# United States Patent and Trademark Office

APPLICATION NO.	FILING DATE	FIRST NAMED INVENTOR	ATTORNEY DOCKET NO.	CONFIRMATION NO.
09/745,074	12/20/2000	Nobuyuki Itoh	55506(840)	9273
. 21874 75	10/05/2004	EXAMINER		
EDWARDS & ANGELL, LLP			RUDE, TIMOTHY L	
P.O. BOX 55874				
BOSTON, MA 02205			ART UNIT	PAPER NUMBER
,			2883

### **DETAILED ACTION**

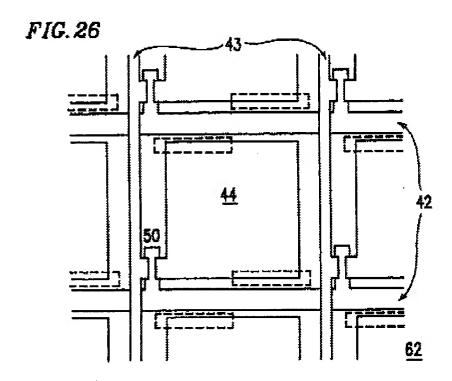
As to claim 1, Hirata discloses in example 10, (col. 18, line 21 through col. 20, line 10) and in related example 11, (col. 20, line 13 through col. 22, line 12, especially col. 20, lines 46-55), Figures 22-30, a liquid crystal display apparatus comprising: a pair of substrates, 41a and 41b, opposing each other; a liquid crystal layer, 63, interposed between the pair of substrates; at least one electrode, 44 and 45, provided on each of the pair of substrates, the at least one electrode being used for applying an electric field across the liquid crystal layer; and at least one low-permittivity insulating film, 47 (Applicant's volume excluding member), wherein:

one of the at least one volume excluding member is provided on the at least one electrode on at least one of the pair of substrates, the volume excluding member being provided so as to be on at least a portion of one side edge of the at least one electrode (dashed rectangles in Figure 26); and the liquid crystal molecules are tilted in a uniform direction from the at least one side edge of the at least one electrode to an opposite edge when a voltage is applied to the at least one electrode (per double-headed arrows in Figures 22 and 27, col. 19, lines 9-19).

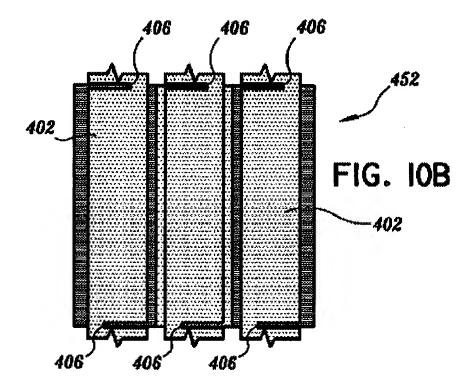
Hirata discloses zero tilt angle (col. 19, lines 1-8), which is parallel alignment that indicates positive dielectric anisotropy, given the molecular alignments indicated in Figures 22 and 27.

Hirata does not explicitly disclose a liquid crystal layer containing liquid crystal molecules having a negative dielectric anisotropy and a side of each of the pair of substrates facing the liquid crystal layer subjected to a vertical alignment treatment.

Hirata does not explicitly disclose vertical alignment mode of operation, however, Hirata teaches that his invention, although disclosed in TN mode, is applicable to other modes of operation (col. 23, lines 60-67).

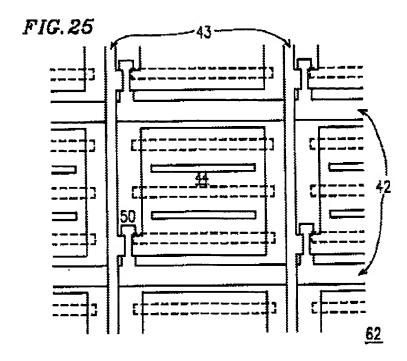
As to claim 2, Hirata discloses a volume excluding member comprising a protrusion, 47, above.

As to claim 4, Hirata in view of Colgan, as combined above, disclose the liquid crystal display as comprised above wherein: a plurality of volume excluding members provided on the at least one electrode on at least one of the pair of substrates, each of the plurality of volume excluding members being provided so as to be on at least a portion of each of an opposing pair of side edges of the at least one electrode but so as not to oppose each other (per dashed rectangles, Figure 26).

As to claim 5, Hirata in view of Colgan, as combined above, disclose the liquid crystal display as comprised above wherein: the at least one electrode on the at least one of the pair of substrates includes a first side edge and a second side edge; and the plurality of volume excluding members are provided along a portion of the first side edge and along a portion of the second side edge (per Figure 26).

As to claim 6, Hirata in view of Colgan, as combined above, disclose the liquid crystal display as comprised above wherein: slit-like openings (Applicant's non-conductive window portion) (solid rectangles in pixel region of Figure 25) is formed in

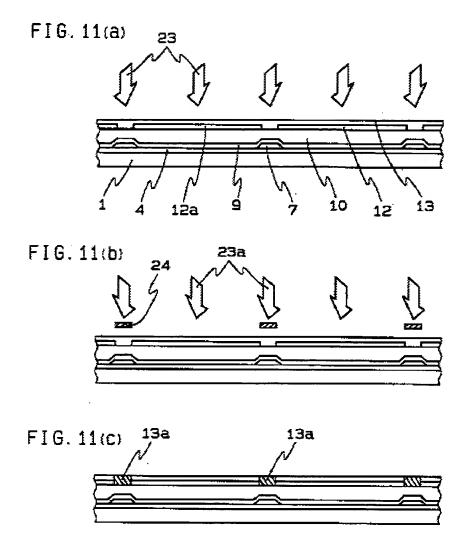
Numano teaches in Embodiment 3 (col. 11, line 35 through col. 12, line 5) and Figures 11(a)-11(c) the use of polarized ultraviolet light to weaken the strength of the alignment layer (reducing the vertical alignment to become more horizontal in alignment) in the region between pixels to reduce cross talk and allow for a higher aperture ratio (col. 12, lines 3-5). The teachings and motivation of Numano expressed in 10 embodiments are considered to be robust to suggest the claimed invention to those having ordinary skill in the art of liquid crystals. Also, providing a direction of the horizontal alignment of the liquid crystal molecules in the at least one pixel portion is substantially identical to a direction of uniaxial horizontal alignment of the liquid crystal molecules in the non-pixel portion would be obvious to those having ordinary skill in the art of liquid crystals to prevent light leaks and thereby improve contrast.

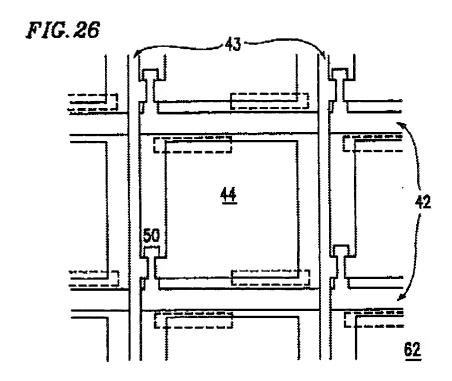
one of the at least one volume excluding member is provided on the at least one electrode on at least one of the pair of substrates, the volume excluding member being provided so as to be on at least a portion of one side edge of the at least one electrode (dashed rectangles in Figure 26); and the liquid crystal molecules are tilted in a uniform direction from the at least one side edge of the at least one electrode to an opposite edge when a voltage is applied to the at least one electrode (per double-headed arrows in Figures 22 and 27, col. 19, lines 9-19).

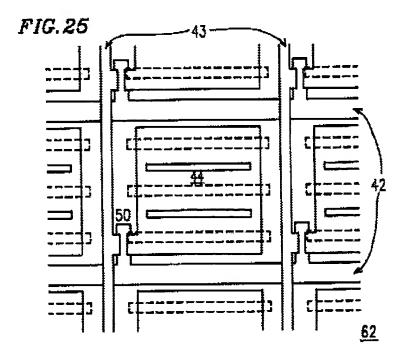
As to claim 5, Colgan in view of Hirata disclose the liquid crystal display as comprised above wherein: the at least one electrode on the at least one of the pair of substrates includes a first side edge and a second side edge; and the plurality of volume excluding members are provided along a portion of the first side edge and along a portion of the second side edge (per Figure 26).

As to claim 6, Colgan in view of Hirata disclose the liquid crystal display as comprised above wherein: slit-like openings (Applicant's non-conductive window portion) (solid rectangles in pixel region of Figure 25) is formed in the at least one electrode on the at least one of the pair of substrates (col. 21, lines 27-32).

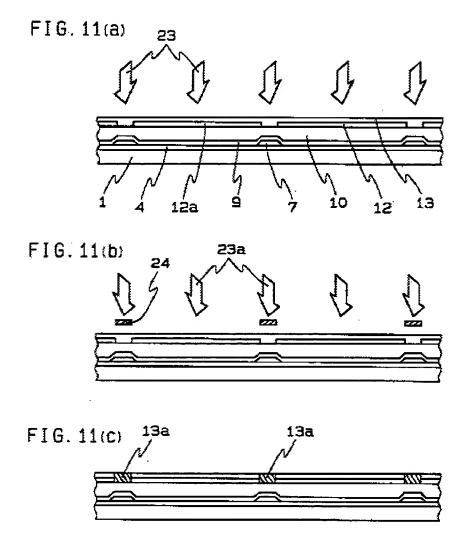
As to claims 7, 13, and 14, Colgan in view of Hirata disclose the liquid crystal display as comprised above such that when voltage is not applied to the at least one electrode, the liquid crystal molecules in the at least one pixel portion are oriented in a vertical alignment.

Numano teaches in Embodiment 3 (col. 11, line 35 through col. 12, line 5) and Figures 11(a)-11(c) the use of polarized ultraviolet light to weaken the strength of the alignment layer (reducing the vertical alignment to become more horizontal in alignment) in the region between pixels to reduce cross talk and allow for a higher aperture ratio (col. 12, lines 3-5). The teachings and motivation of Numano expressed in 10 embodiments are considered to be robust to suggest the claimed invention to those having ordinary skill in the art of liquid crystals. Also, providing a direction of the horizontal alignment of the liquid crystal molecules in the at least one pixel portion is substantially identical to a direction of uniaxial horizontal alignment of the liquid crystal molecules in the non-pixel portion would be obvious to those having ordinary skill in the art of liquid crystals to prevent light leaks and thereby improve contrast.
